**S12A AMENDMENT OF PLAN APPLICATION  
APPROVED NGAU TAM MEI  
OUTLINE ZONING PLAN NO. S/YL-NTM/12**

**FURTHER INFORMATION (4)  
May 2023**

**RESPONSE-TO-COMMENT – EPD**

**Proposed Rezoning From “R(C)” To “G/IC” for  
a Proposed “Social Welfare Facilities” (Residential Care Homes for The Elderly) (RCHE)  
Lot 4823 in D.D.104, 81 San Tam Road, San Tin, N.T.  
S12A Application for Planning Application No. Y/YL-NTM/9  
Response-to-Comment – EPD  
(updated 13 April 2023)**

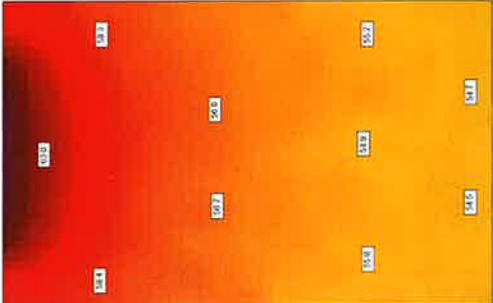
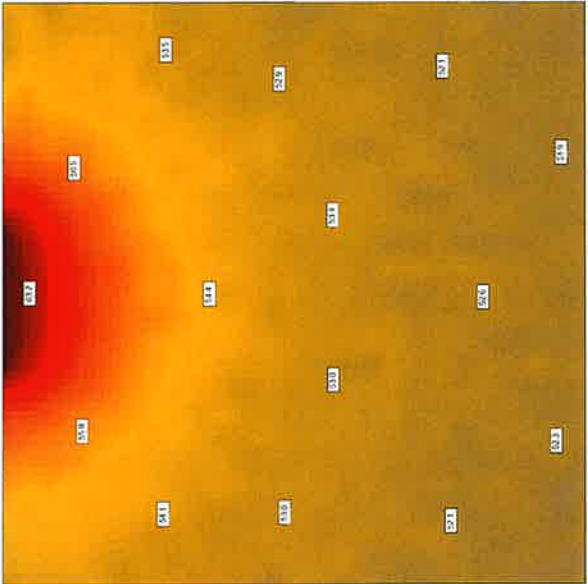
Comments	Response
<p>(i) please indicate the location of the exhaust of the proposed STP in a location map with the nearest ASRs (including the existing ones and the proposed development) and provide their separation distances for evaluation of the odour impact. Please be reminded that the exhaust outlet of the proposed on-site STP should be designed properly and located away from all nearby ASRs (including the air sensitive use of the proposed development such as the residential units on top of the STP) as far as possible to avoid causing any odour impact.</p> <p>(ii) Please also list out the sewage treatment capacity of the proposed on-site STP and state clearly if the design of the proposed on-site STP would observe and follow the Environmental Consideration specified in EPD Guidelines for the Design of Small Sewage Treatment Plants for minimization of the odour impact from the proposed STP during operation phase.</p> <p>(b) <b>Cooking Fume/ odour from the proposed kitchen:</b> Please observe and follow the guidelines recommended by EPD’s Control of Oily Fume and Cooking Odour from Restaurants and Food Business to avoid causing air and odour nuisance. In particular, the exhaust vent of the kitchen should be positioned away from nearby ASRs as far as possible. Please supplement. Please also incorporate R-t-C #7 in this section.</p> <p>6. Section 6: Please clarify if there is any adverse air quality/ odour impact arising from</p>	<p>The STP will serve less than 2000 population, hence the Environmental Consideration specified in EPD Guidelines for the Design of Small Sewage Treatment Plants have been incorporated.</p> <p>The location of the exhaust of the proposed STP has been indicated in Figure 2.1.2. The location of the exhaust has been designed as far as possible all nearby ASRs. Considering that at source mitigation measures would be applied, no adverse odour impact from the proposed on-site STP is anticipated</p> <p>The recommendations on EPD’s Control of Oily Fume and Cooking Odour from Restaurants and Food Business have been incorporated.</p> <p>R-t-C#7 have also been incorporated.</p> <p>The tentative location of the STP/Kitchen exhaust has been designed as far as possible all</p>
